ADDENDUM 01

DATE 09.09.22
PROJECT NO. 2141
PROJECT LOGAN FAMILYSEARCH CENTER REMODEL
FROM STUDIO 333 ARCHITECTS

This Addendum consists of 1 page and the attached Drawing Sheets A1.11, A1.13, A4.1, E1.11 and E6.11.

1. Sheets A1.13 and A1.11:

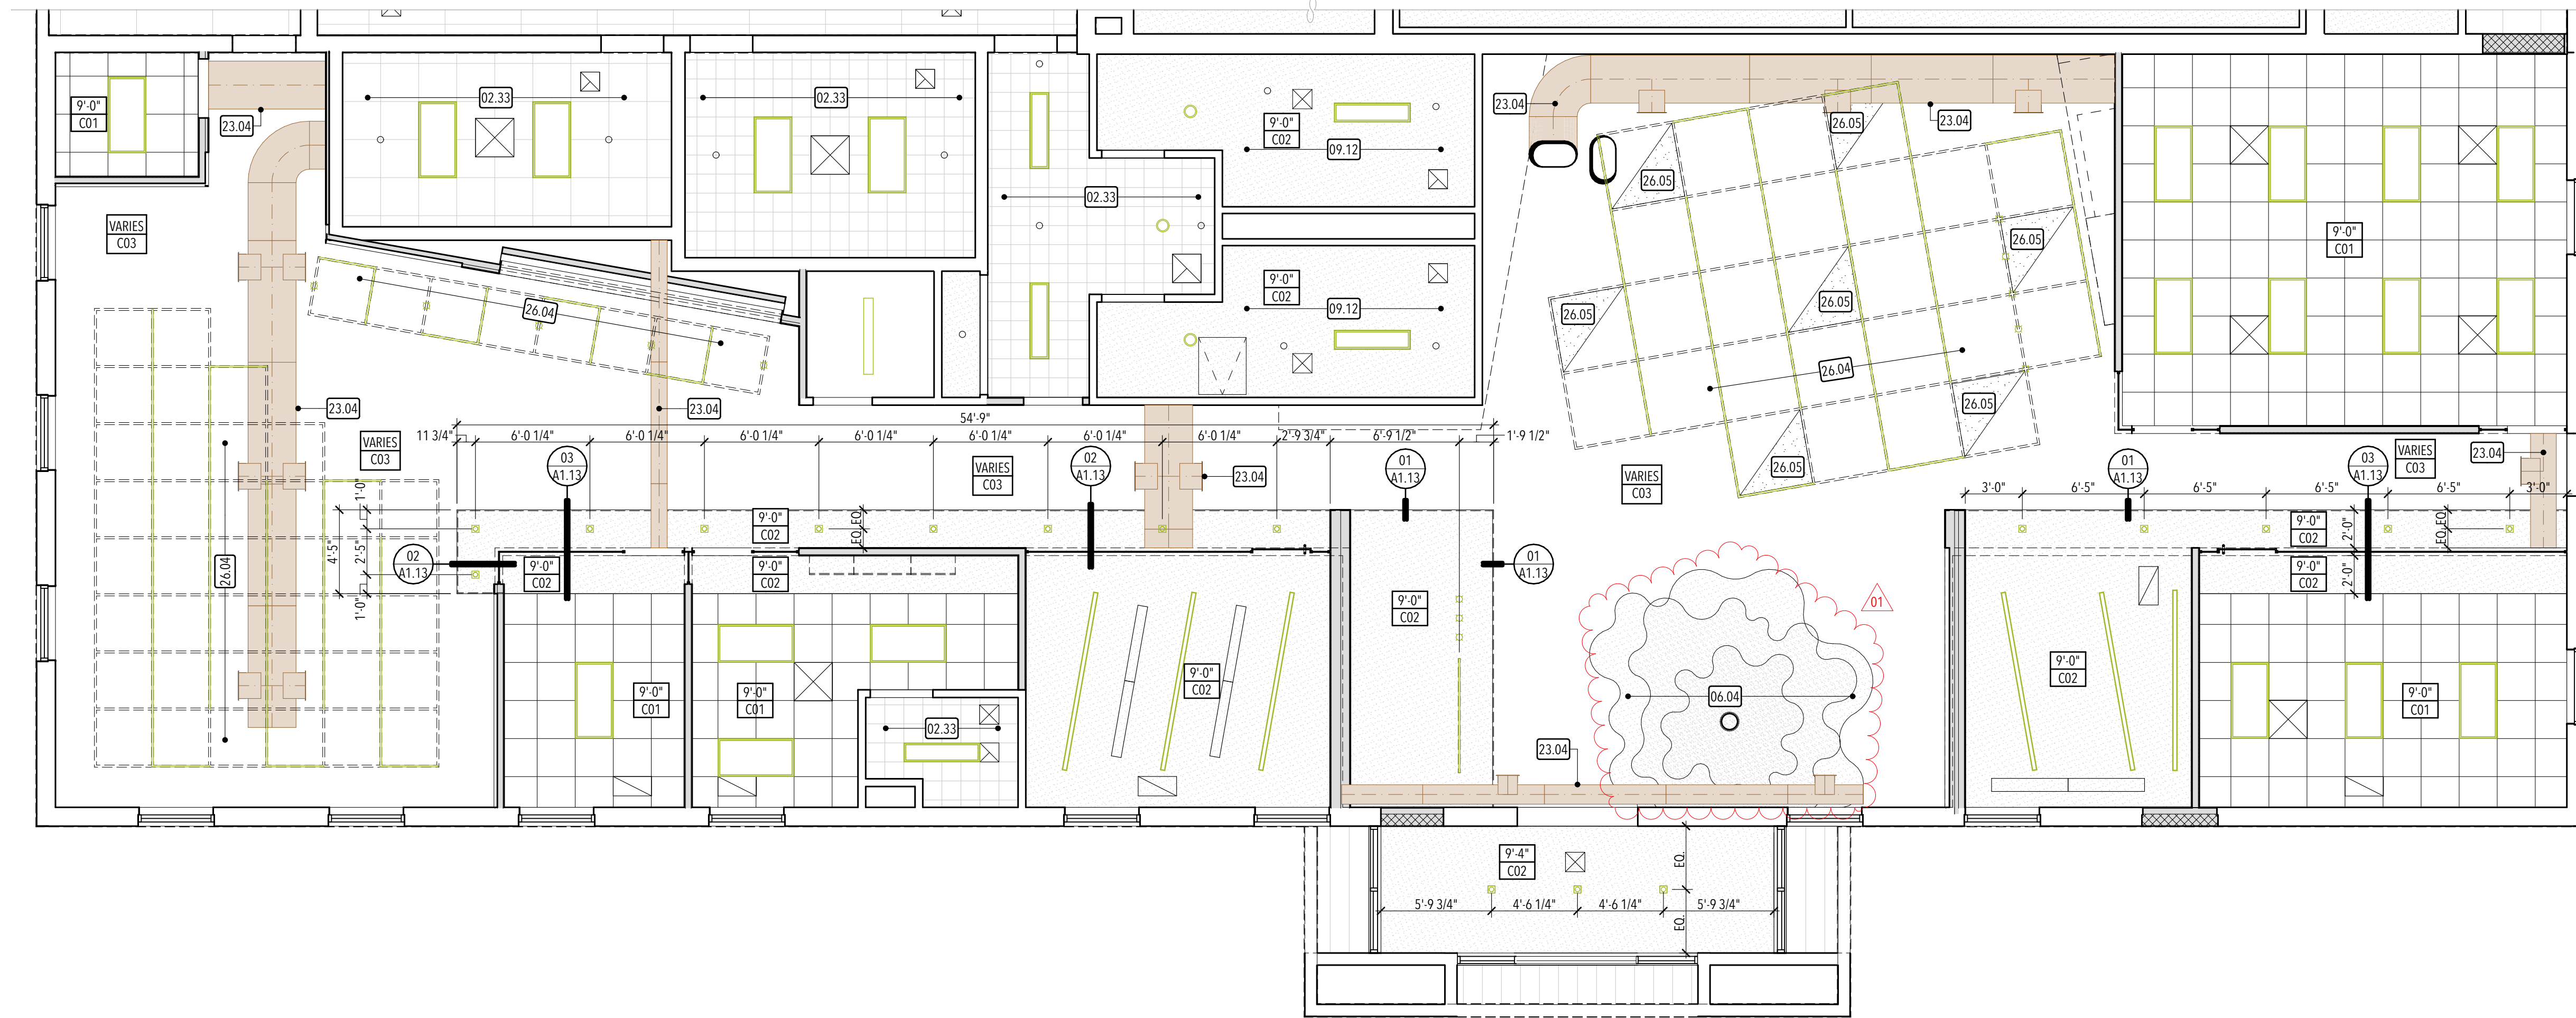
a. The 3-tier tree canopy at Child's Play Area 104 shall be fabricated and installed by Ogden Blue. Detail 4/A1.13 has been deleted. Keyed note '06.04' has been changed to read as follows: "3-tier simulated tree canopy system - re: details. Tree trunk represented with reclaimed lumber by Euclid Timber, Heber City, UT. Coordinate install with table below. 3-tier tree canopy shall be fabricated and installed by Ogden Blue (Richard Scott 801.392.7573)."

2. Sheet A4.1:

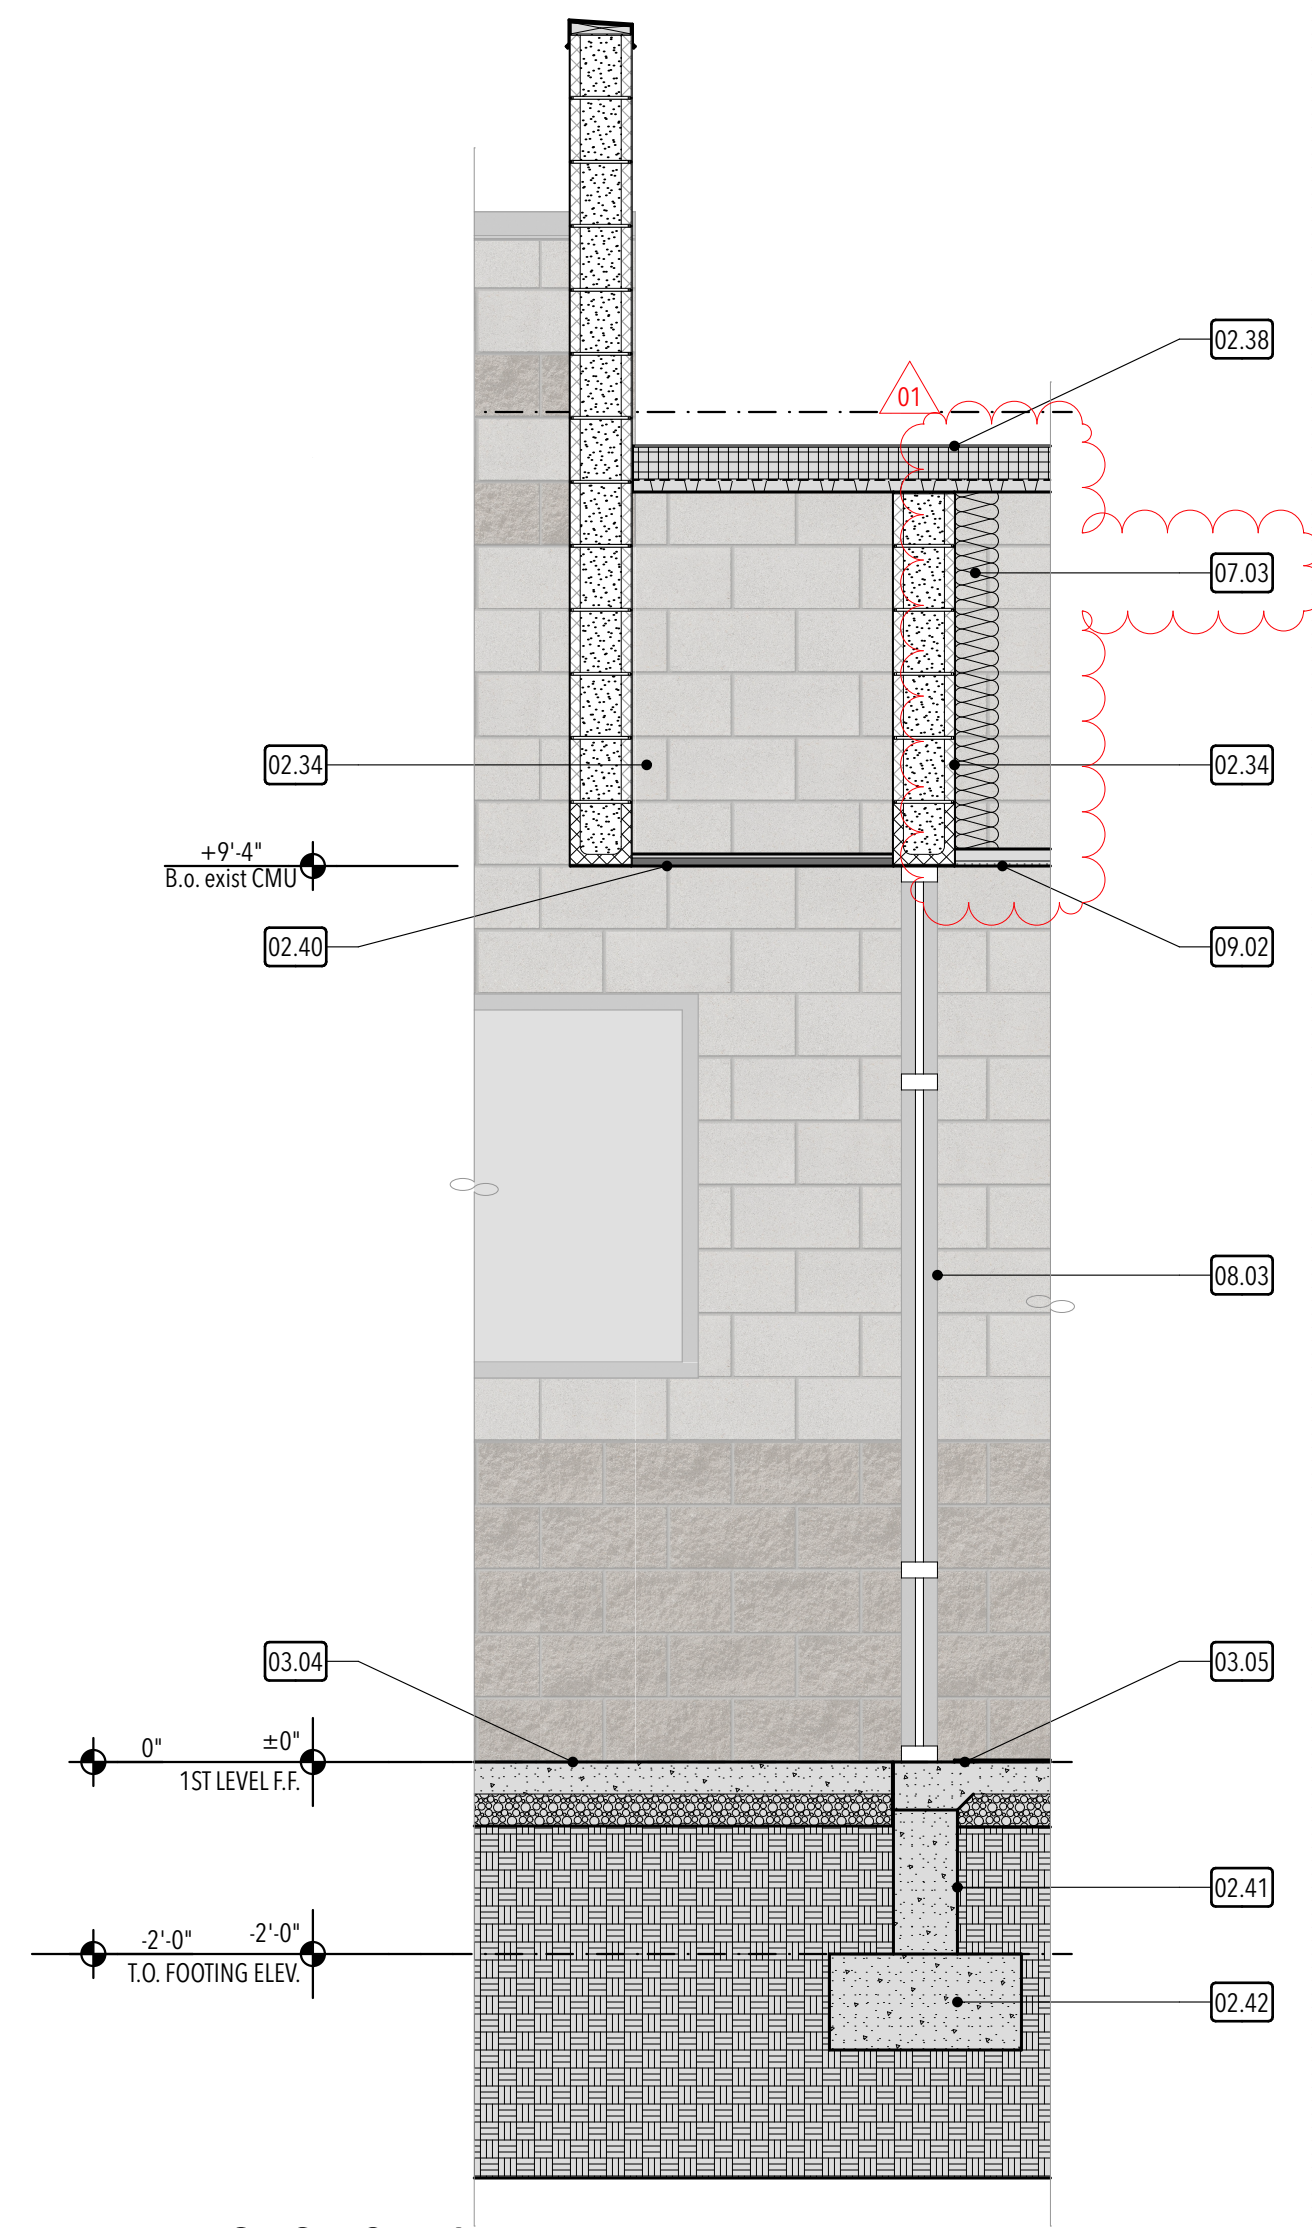
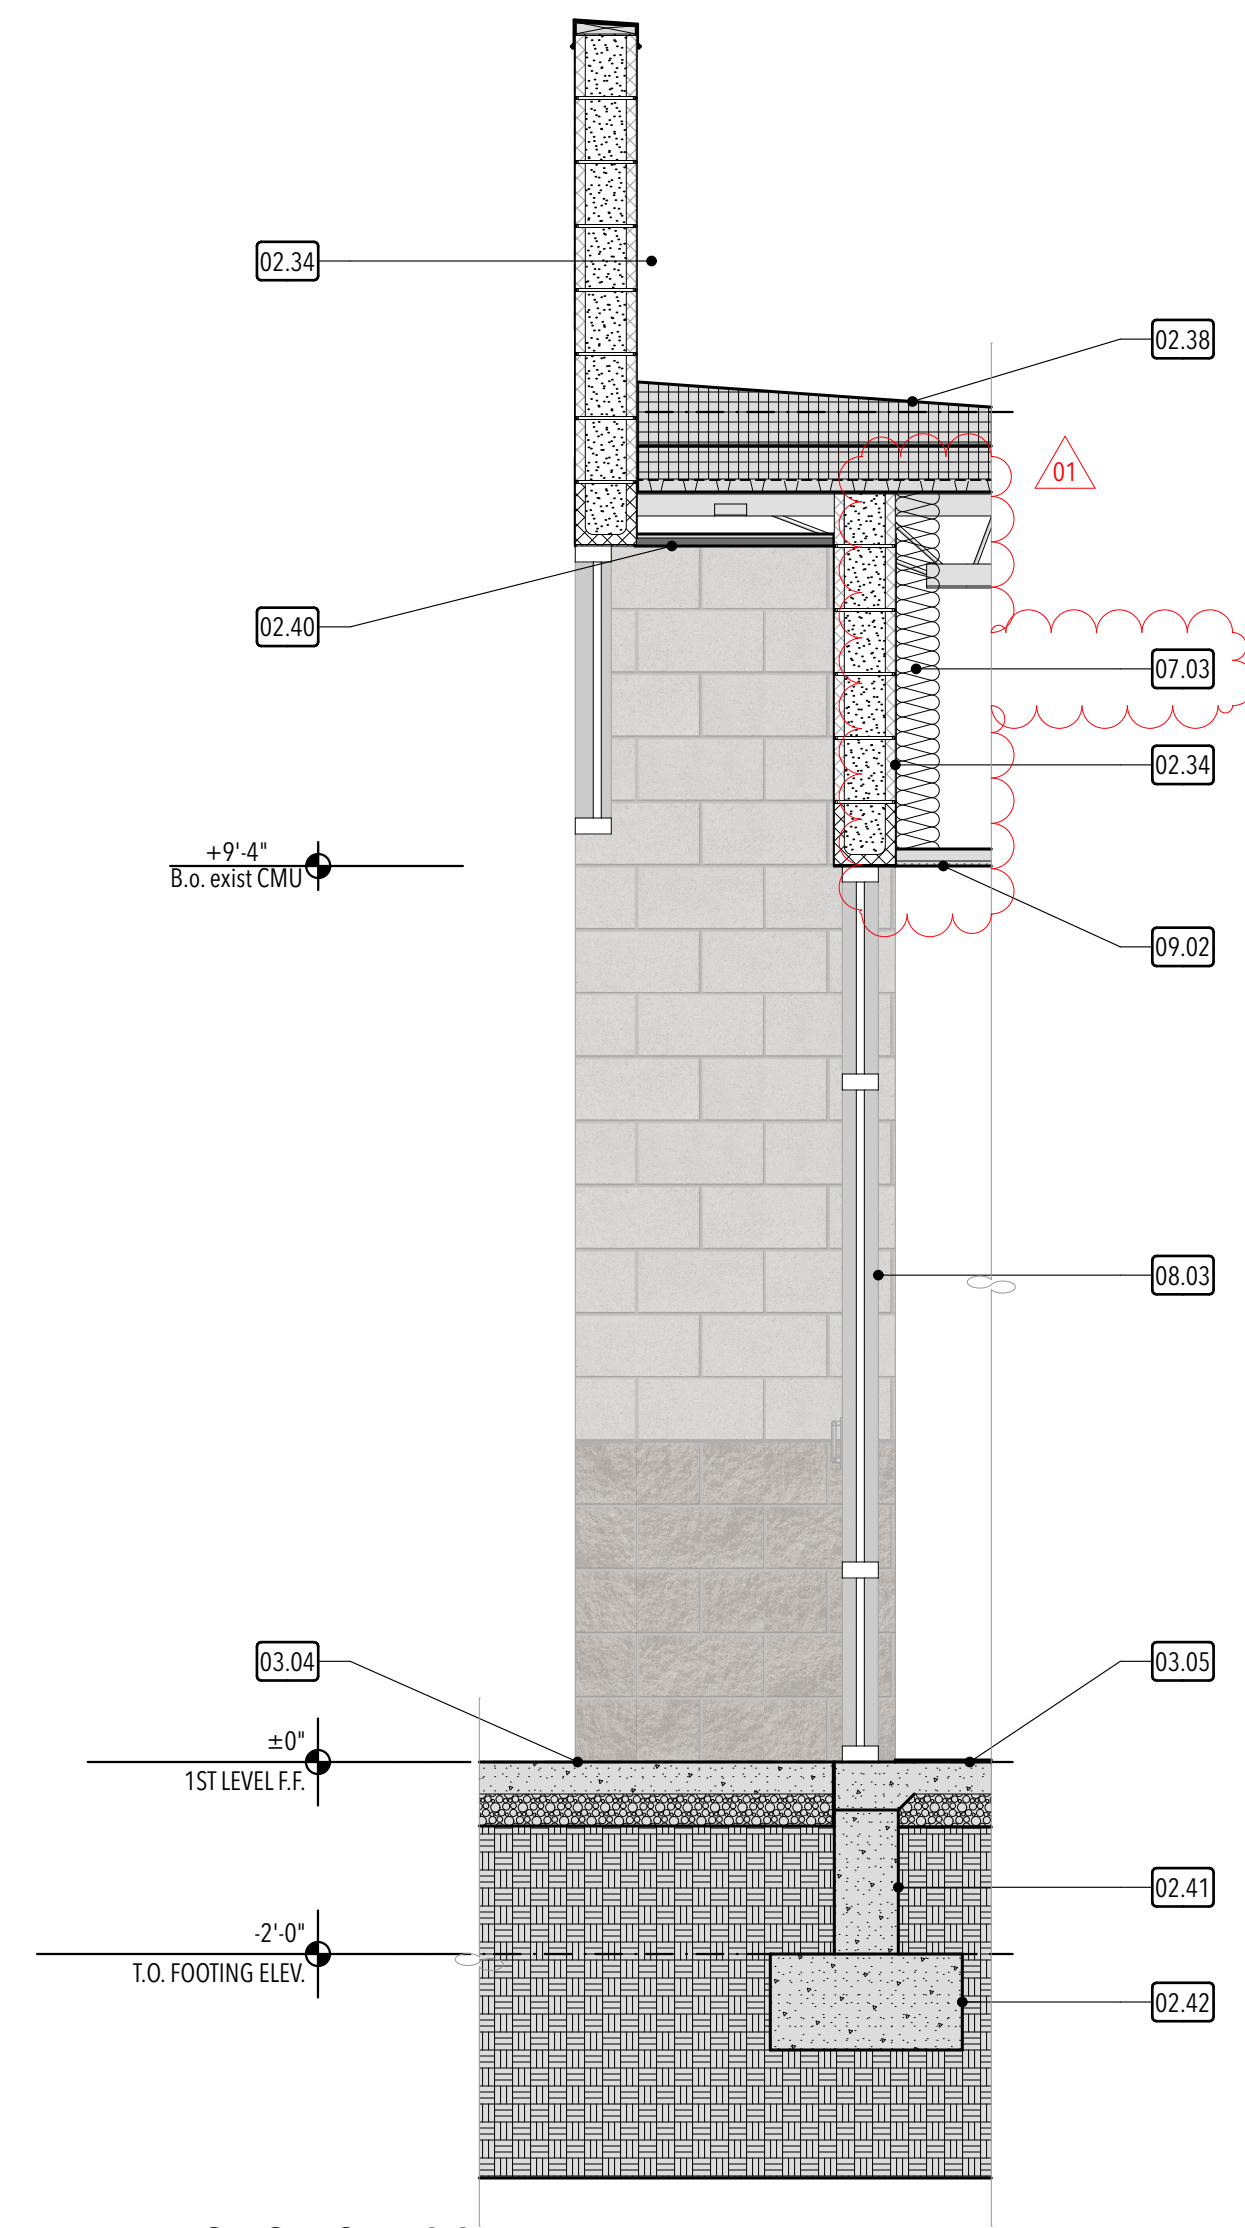
a. Add batt insulation at the exterior CMU walls at the new Vestibule 105 from the top of the new ceiling to the bottom of the existing metal roof deck.
